REQUEST FOR INFORMATION

RFI NUMBER	NL-RFI-069				
ISSUE DATE (YY/MM/DD)	September 25, 2011				
PRIORITY	H	X	M	L	
REQ'D RESPONSE DATE	September 28, 2011

Hope Bay Mining Project

Subject:	Doris Sediment Pond Liner	Project Zone/Area:	Doris North
Company:	Nuna Logistics Ltd	Station/Location:	Sediment Pond
Attention:	Doug Fielding / Jerry Graham	Discipline:	Civil

Option D

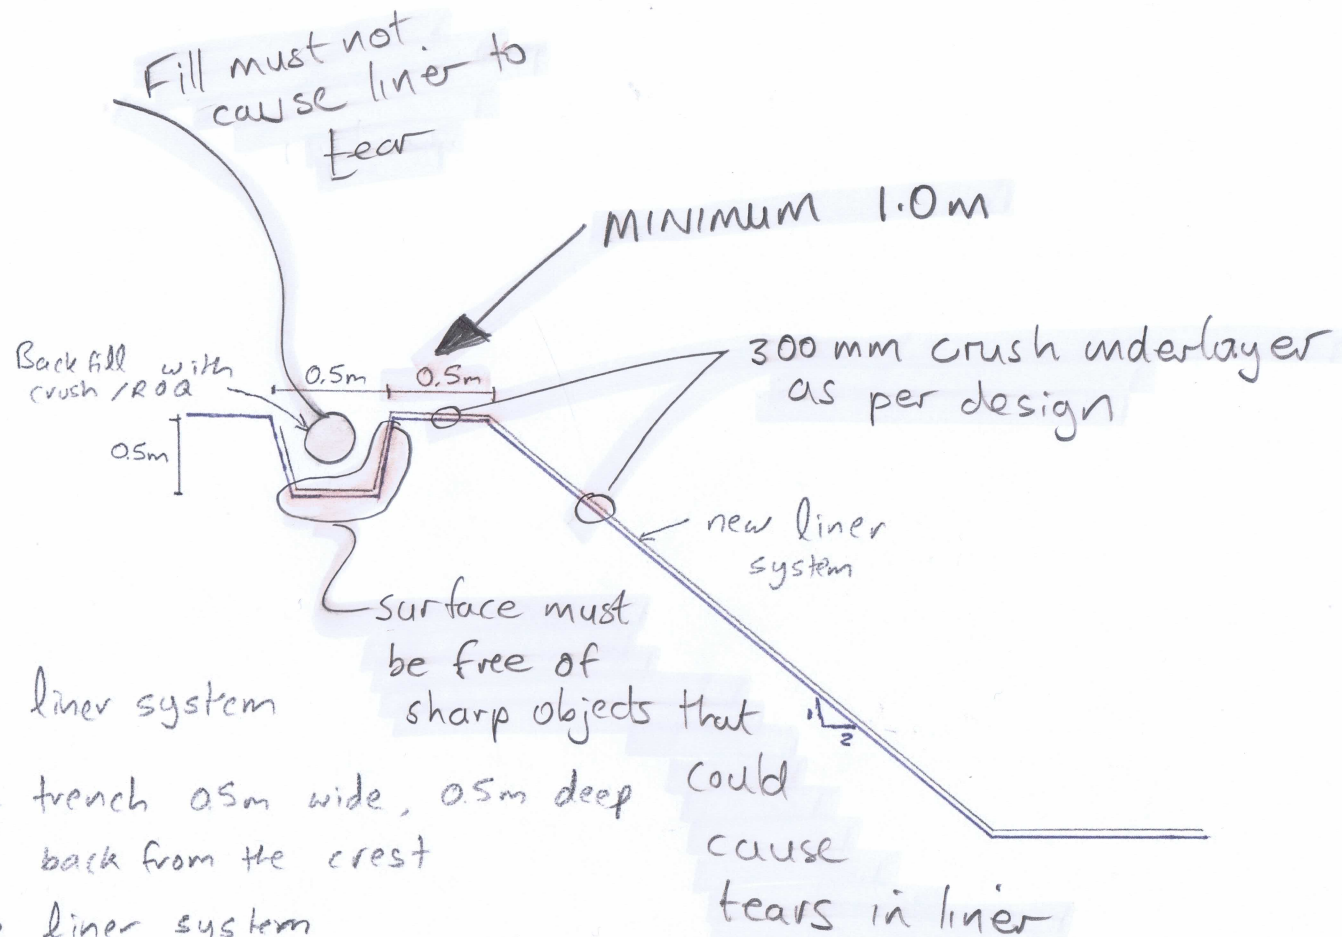
After further discussion with Layfield, the proper method to tie in the new liner would be to construct a key trench at the top of the berm. This technique would allow the new liner to cover the floor as originally intended, yet cover the existing liner on the slopes to assure proper containment. As illustrated in the attached sketches, this key trench would assure a stable liner. Before backfilling the key trench, the liner will be fusion welded and tested.

- ① remove old liner system
- ② Excavate a trench 0.5m wide, 0.5m deep and 0.5m back from the crest
- ③ Key in the liner system

SRK is satisfied with the proposed modification as suggested provided the following is adhered to:

1. The tuck trench must be set back at least 1.0 m from the crest as opposed to 0.5 m as suggested
2. The 300 mm crush liner bedding layer must be maintained under the liner sandwich up to the edge of the tuck trench
3. The liner in the tuck trench must be adequately bedded and protected so as to not cause major tears in the liner. Small puncture holes are acceptable. These elements are also illustrated on the attached sketch.
